STATE OF NEW HAMPSHIRE  
INTER-DEPARTMENT COMMUNICATION

**FROM:** Wayne Wheeler, P.E.  
Permitting & Design Review Section

**SUBJECT:** Stage 1 Phase 1 Anchor Trench Repairs/NCES/Bethlehem/  
DES-SW-SP-03-002

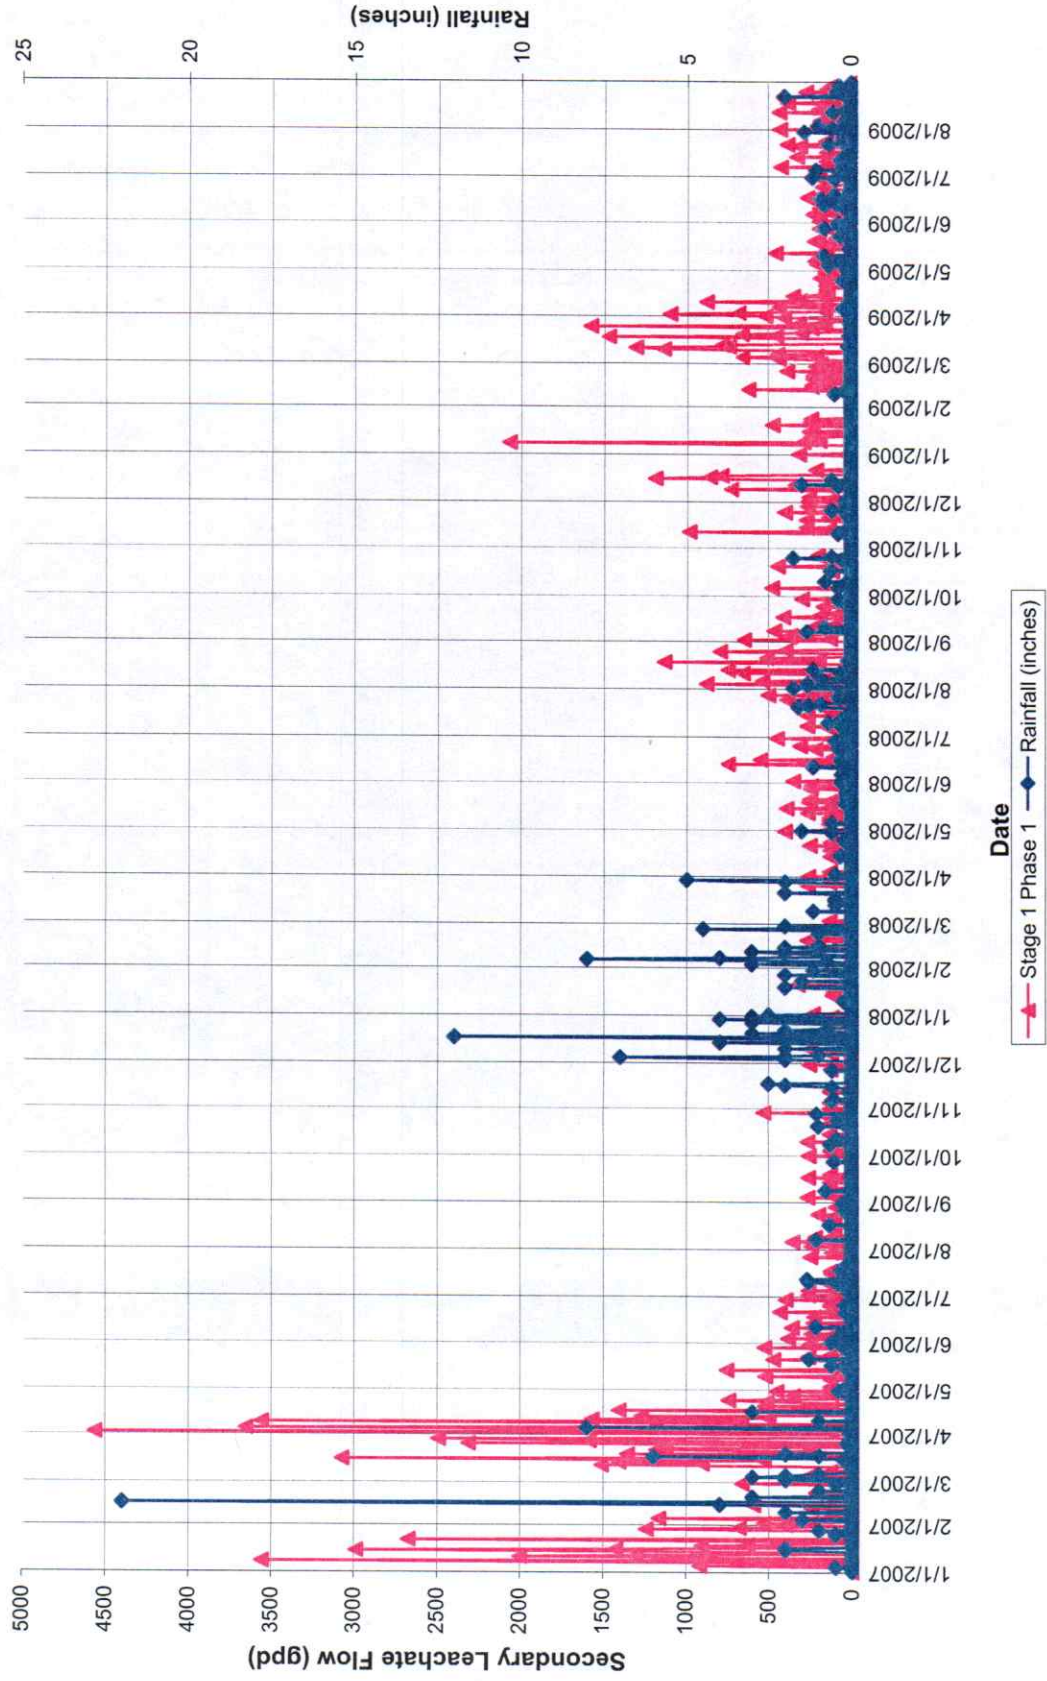
As shown the Stage 1 Leachate Flow charts (esp. Phases 1 and 4), secondary leachate flows appear to have substantially decreased following the repairs.

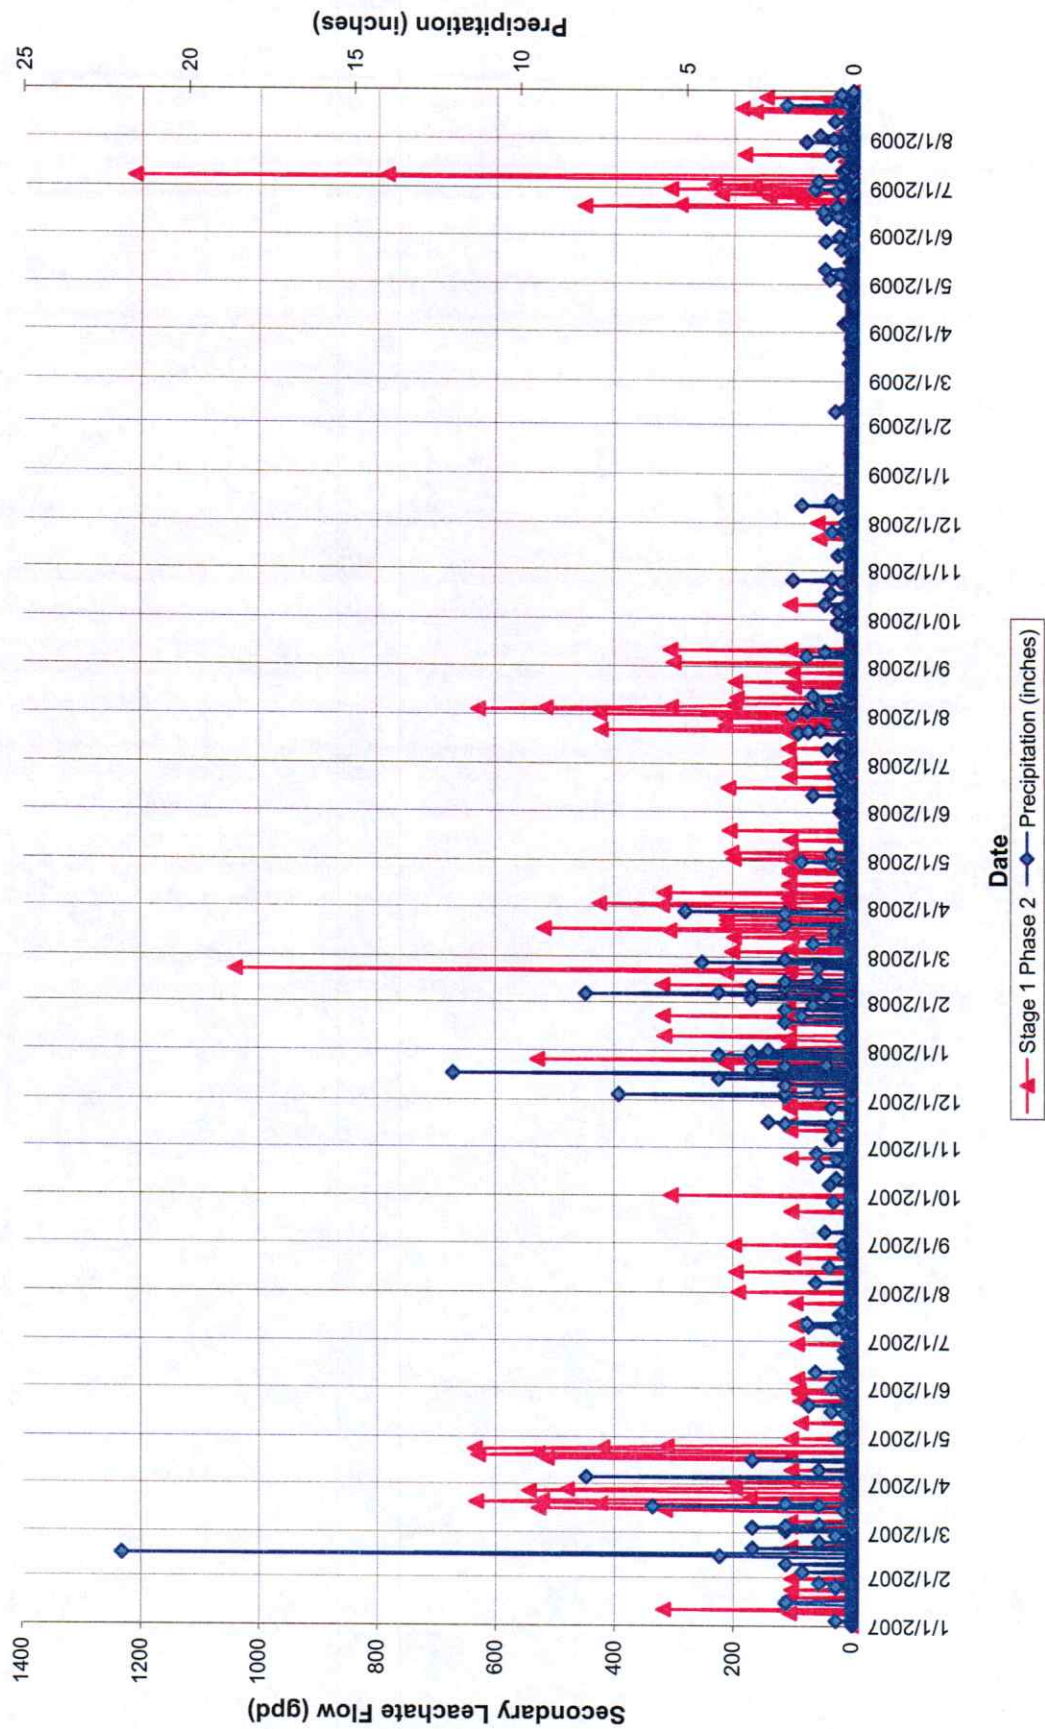
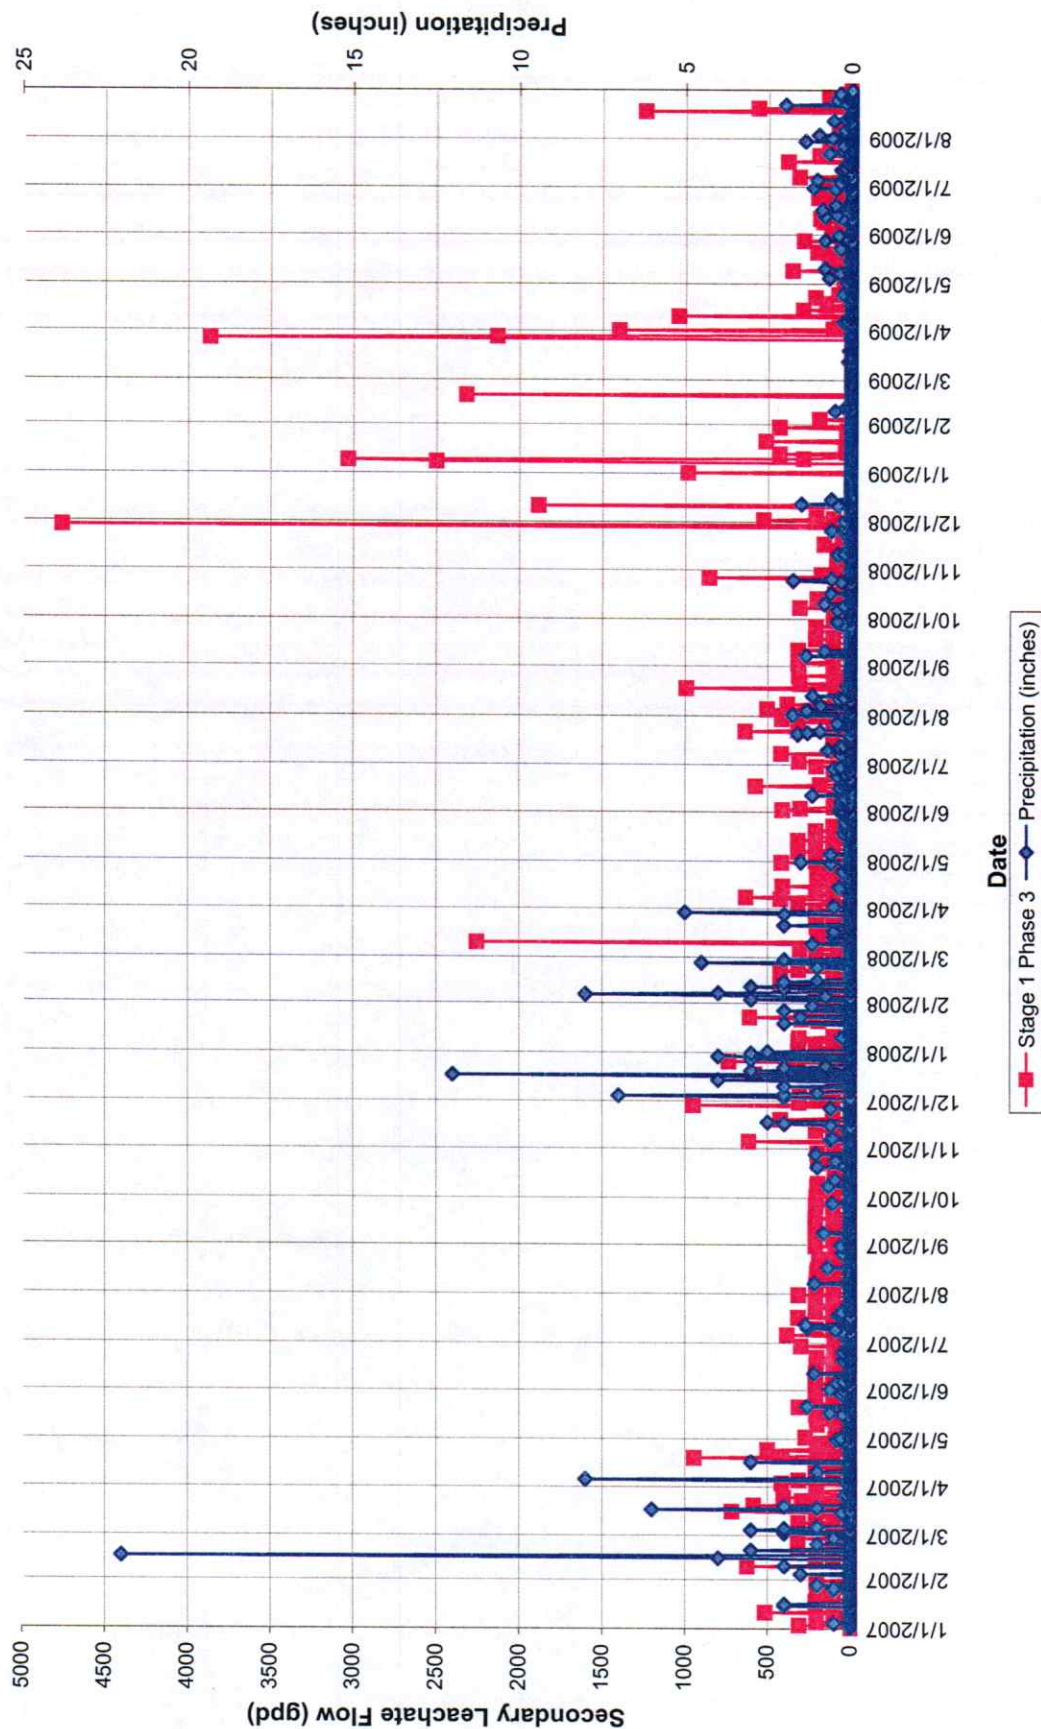
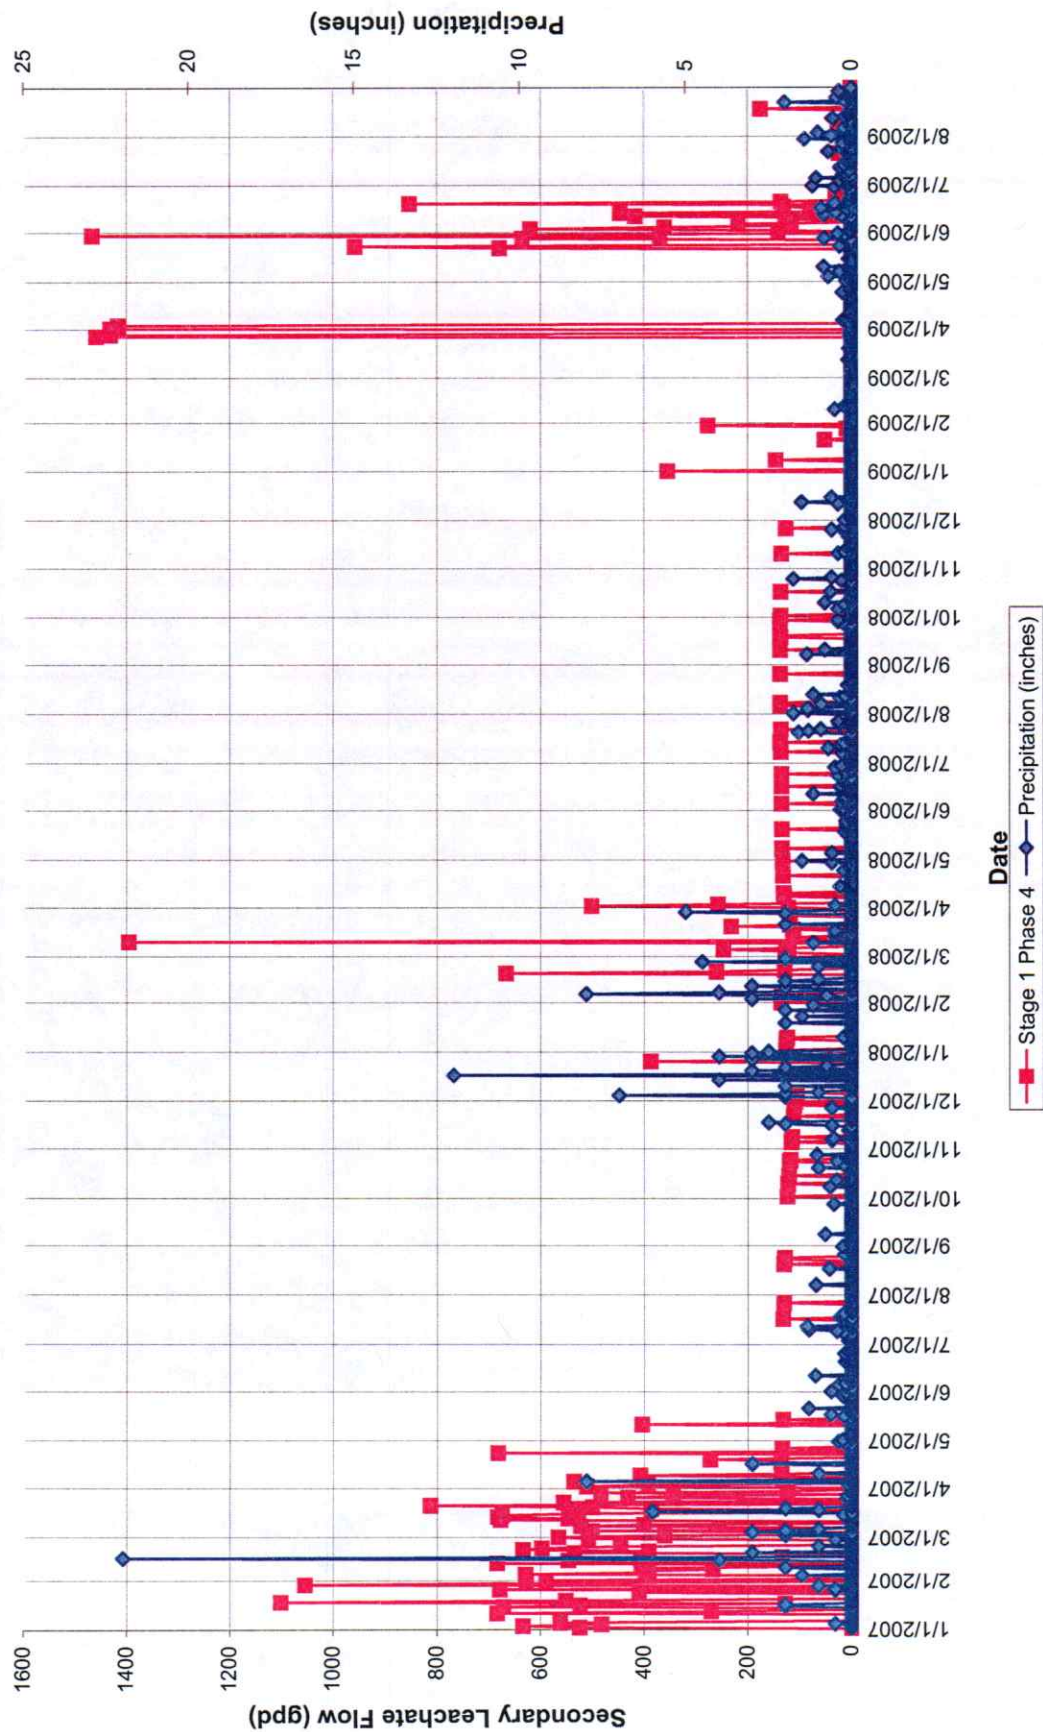
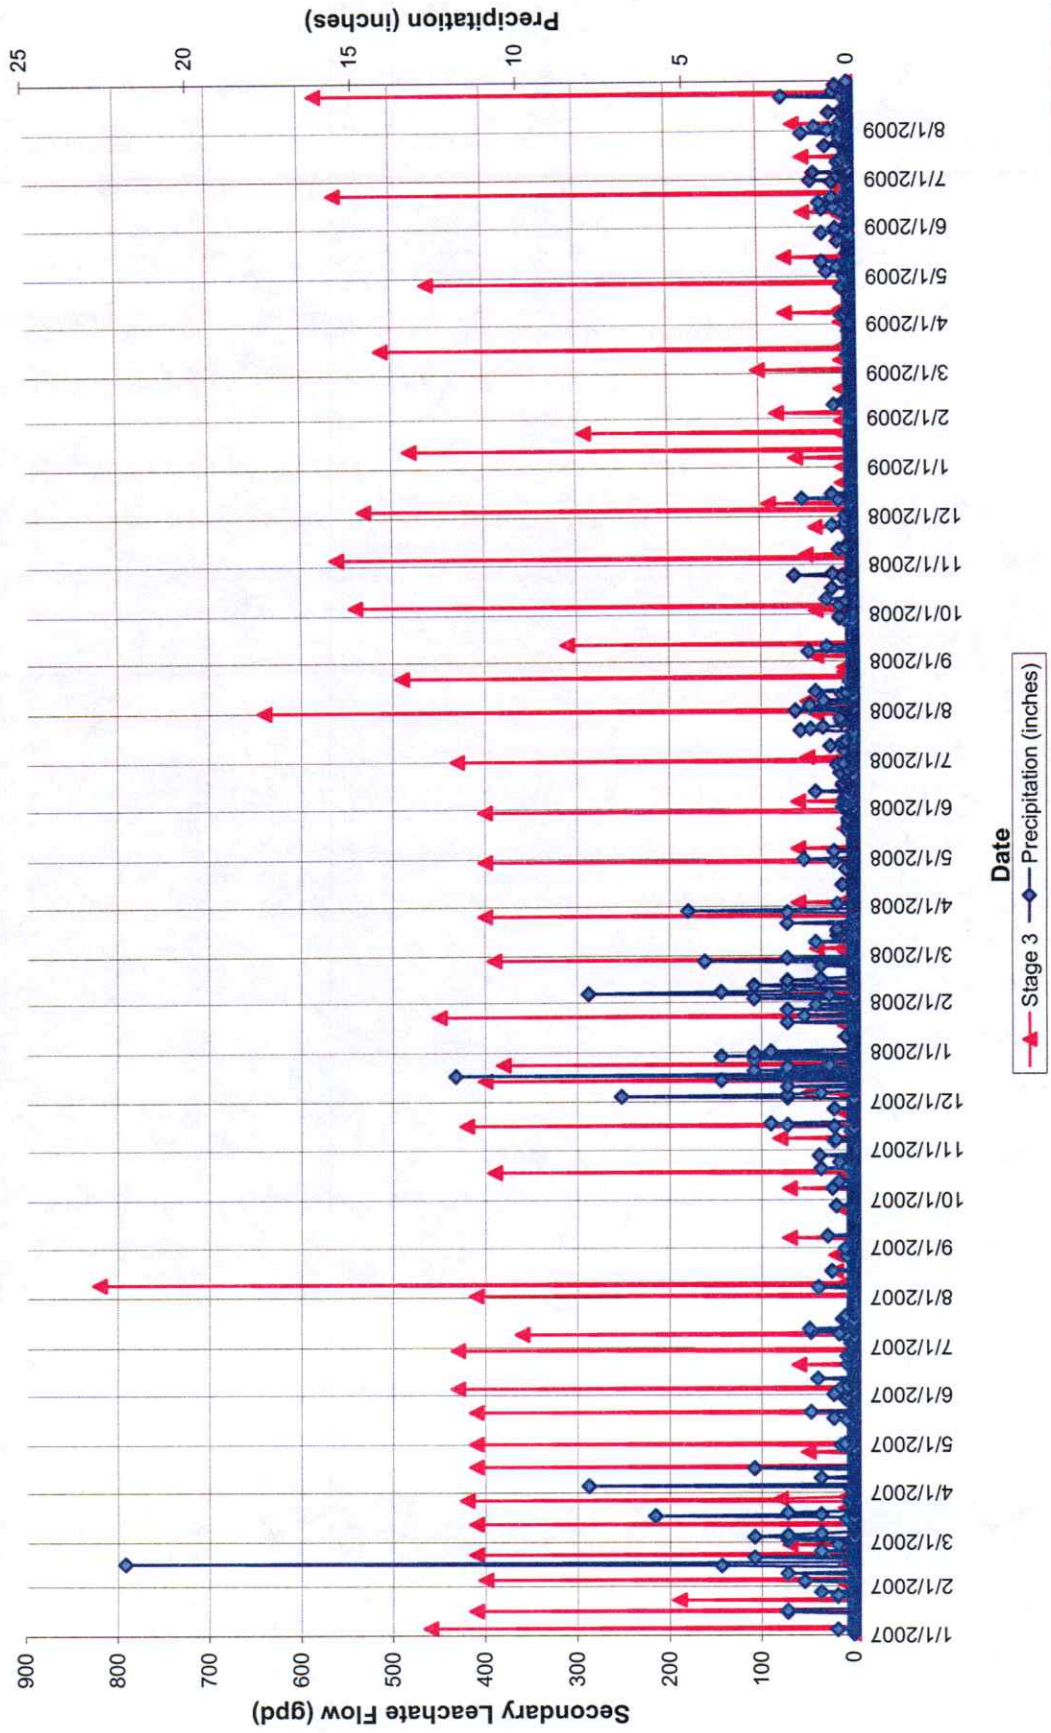
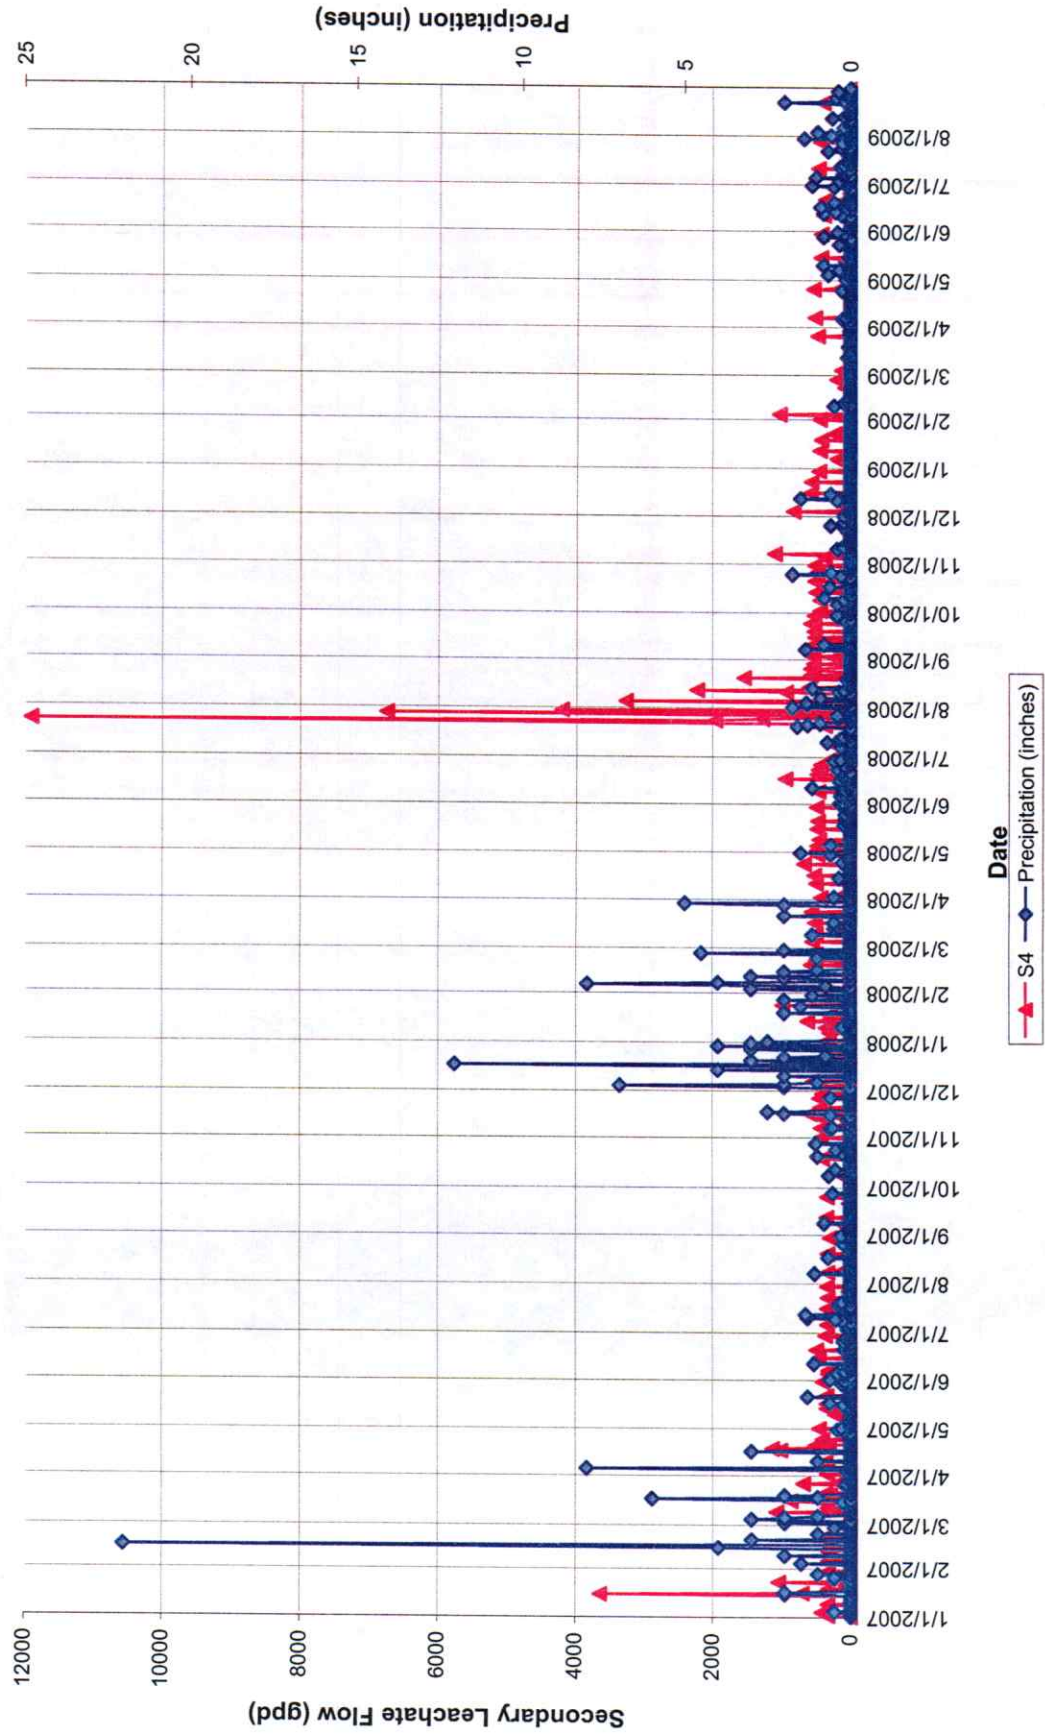
As shown on the attached charts, Stage 1 secondary flows appear to be influenced by either rainfall events or runoff. In addition and as shown on the attached charts, there appears to be a relationship between total VOCs measured at MW B-913M and secondary leachate flows. I have also plotted Total VOCs for each of the Stage 1 phases.
